**MEETING OF THE
PLANNING AND ZONING BOARD
QUASI-JUDICIAL PUBLIC HEARING**

May 21, 2019

**TOWN OF BAY HARBOR ISLANDS
DRC STAFF
PLAN REVIEW**

**RE: BELIZA 1170 102 STREET
RESPONSE TO COMMENTS BY MICHAEL MILLER PLANNING ASSOCIATES, INC.**

PHOTOMETRIC PLAN

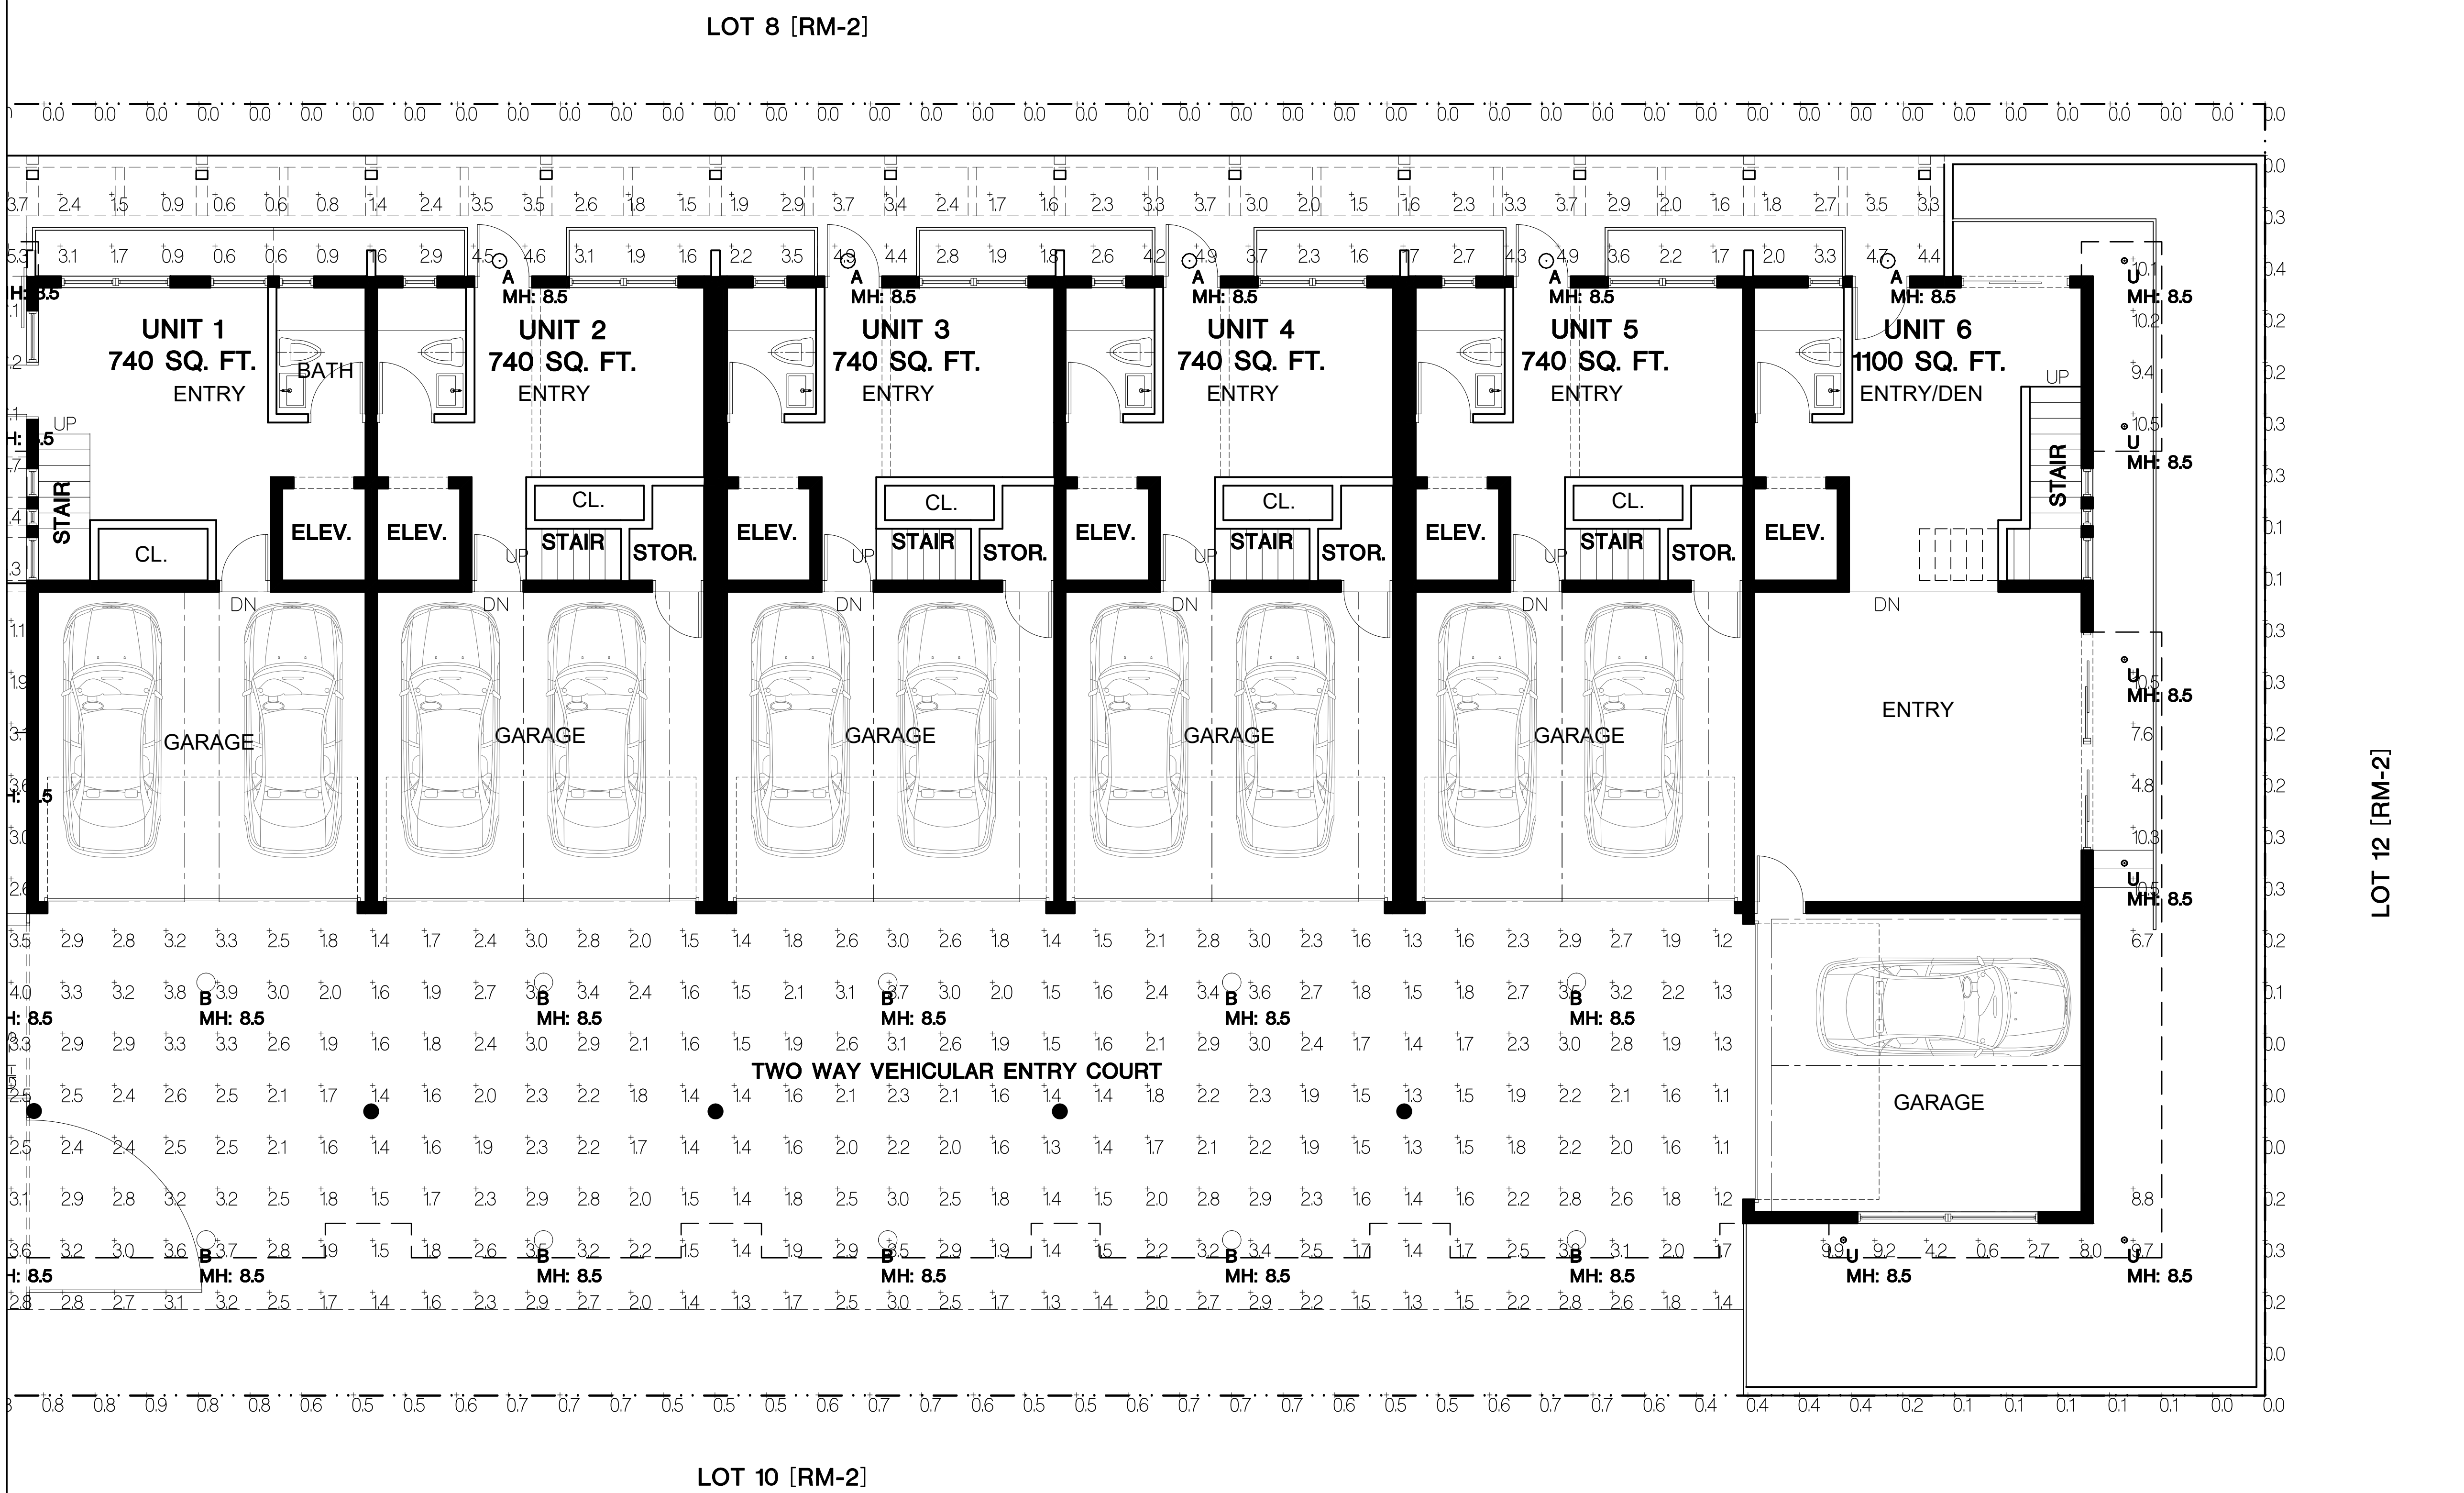
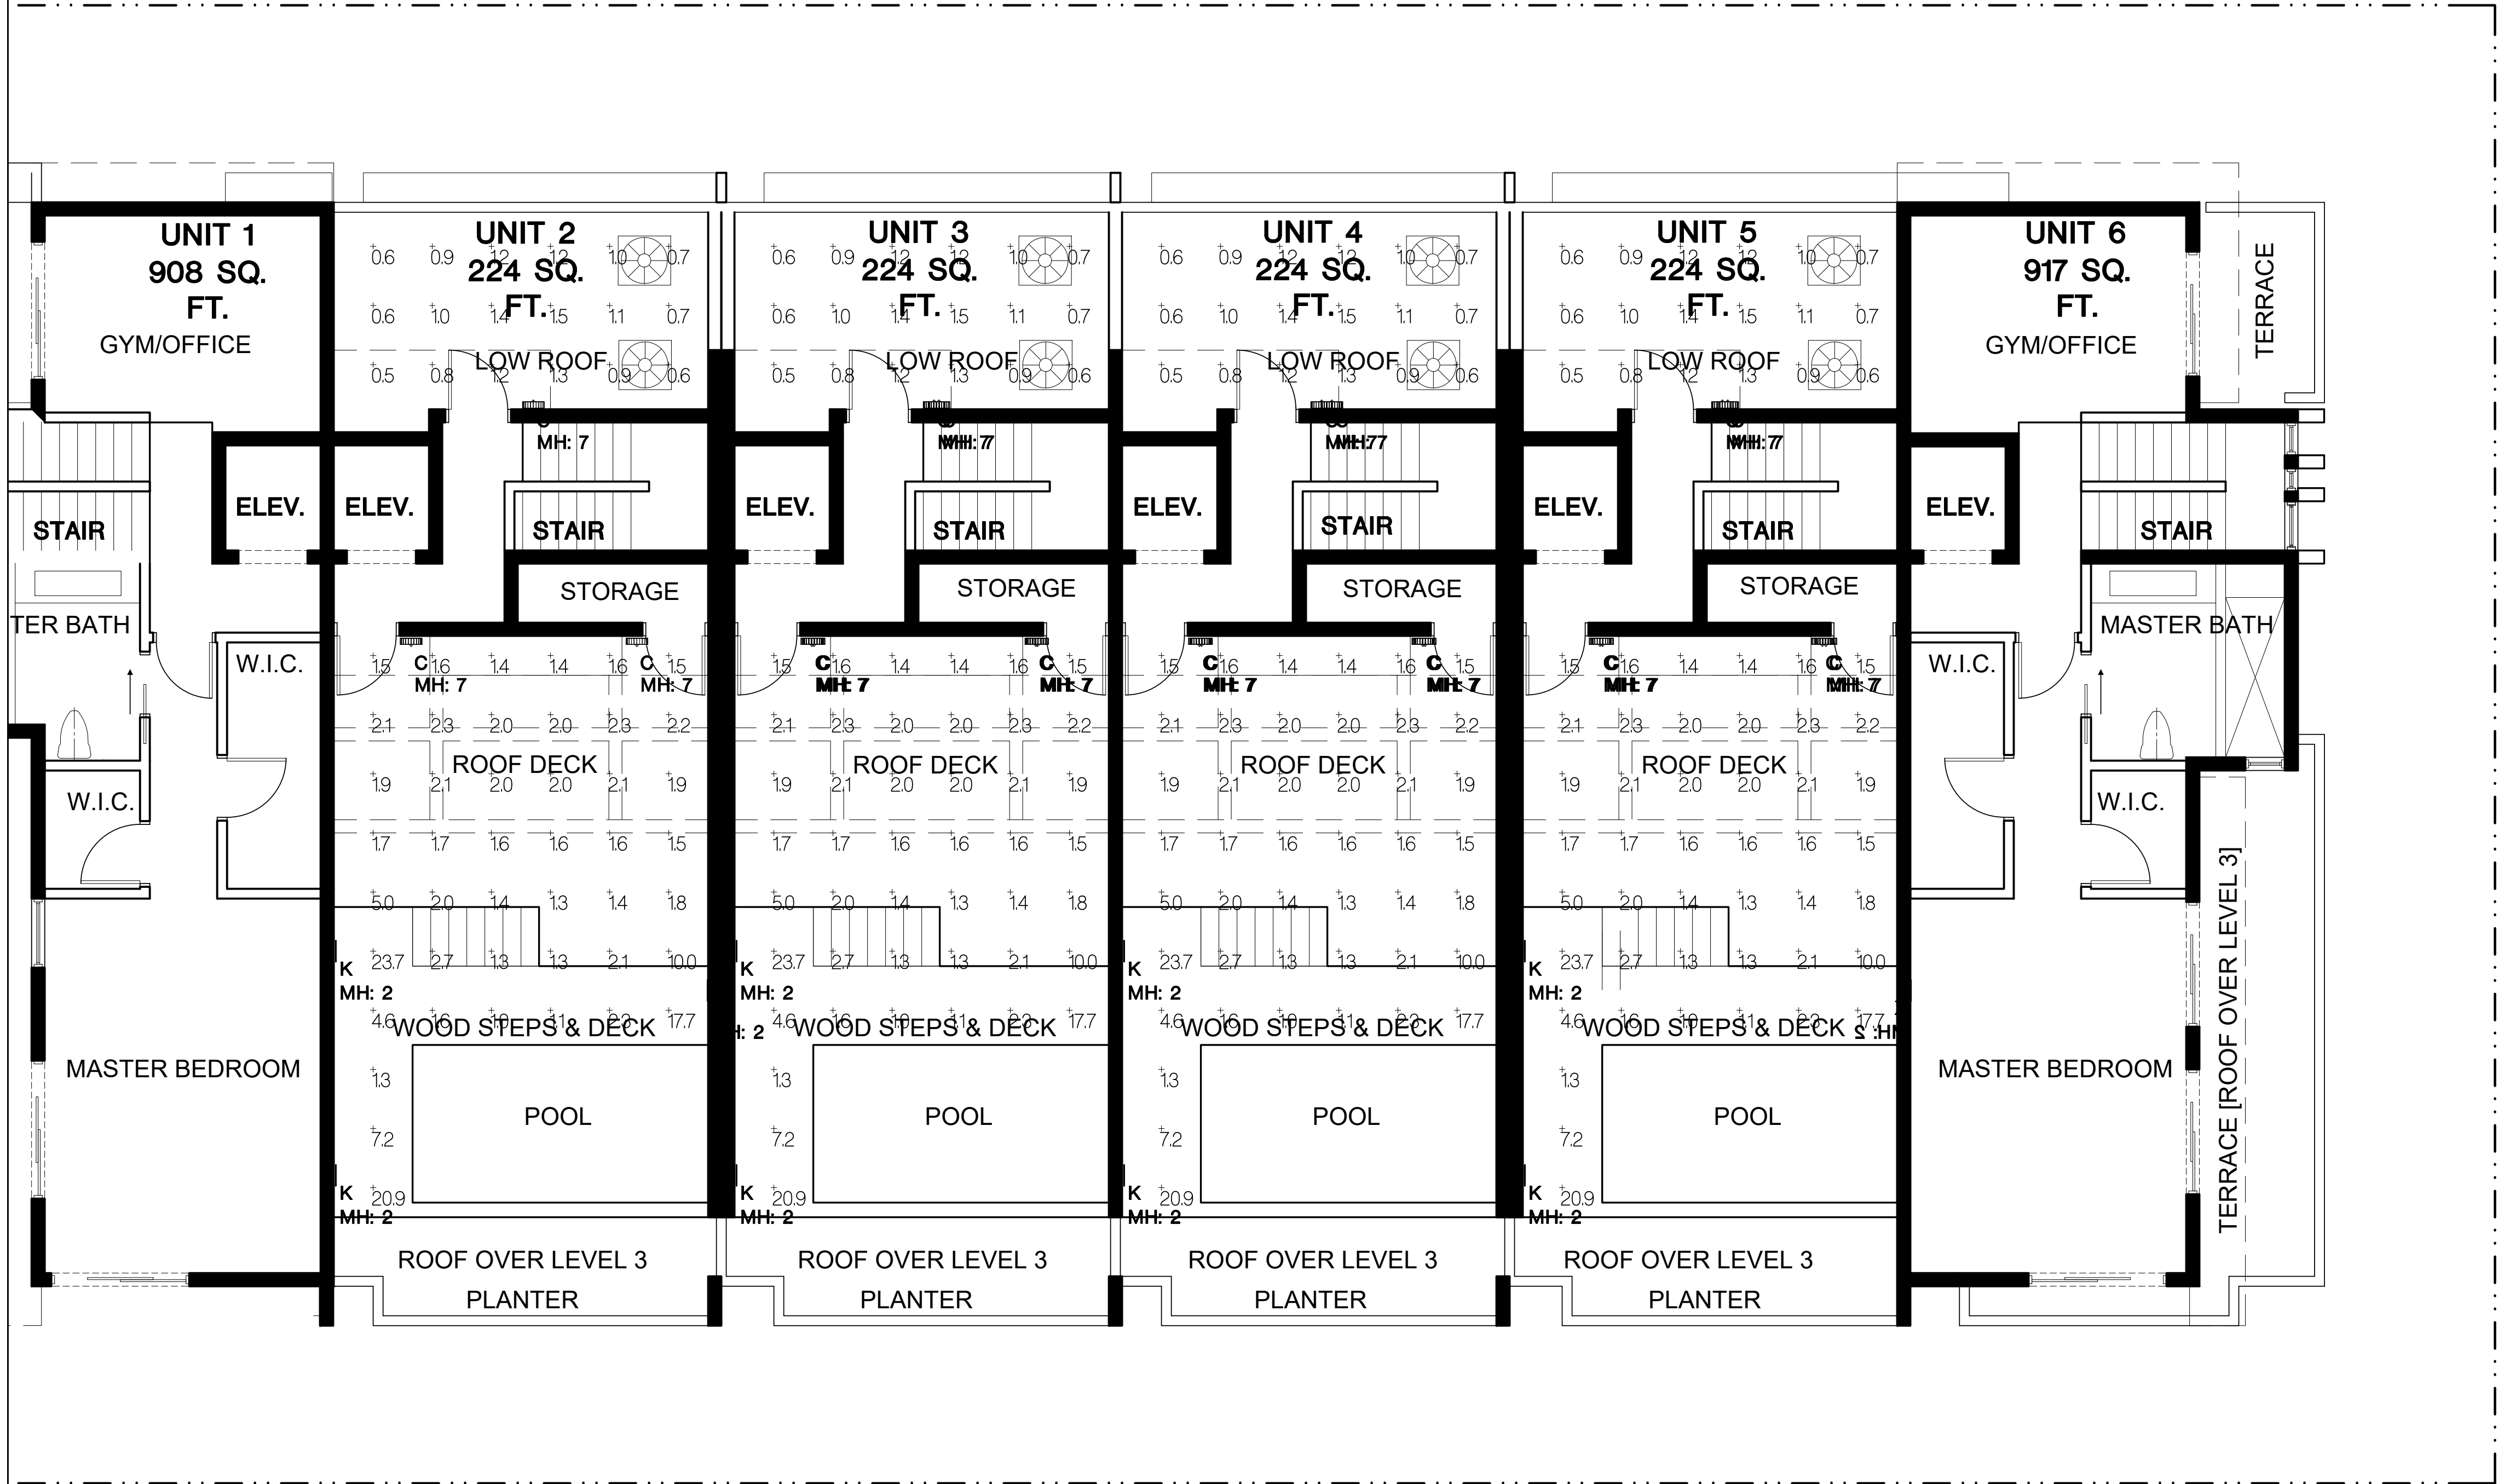
THE PHOTOMETRIC LIGHTING PLAN IS INCOMPLETE; MISSING ITEMS 23-19€(2)(d), (e), (f) AND (h)

Please note that we submitted 3 sheets of Photometric Plans including Level 1/Site, Level 4 Roof, Level 5 Roof. The Luminaire Schedule shows the lumens, the watts, the manufacturer, the mounting heights, and all illumination values in fc. We also include in this submittal the cut sheets for all exterior lighting fixtures. During our DRC review Michael Miller agreed that the Photometric Plans are satisfactory.
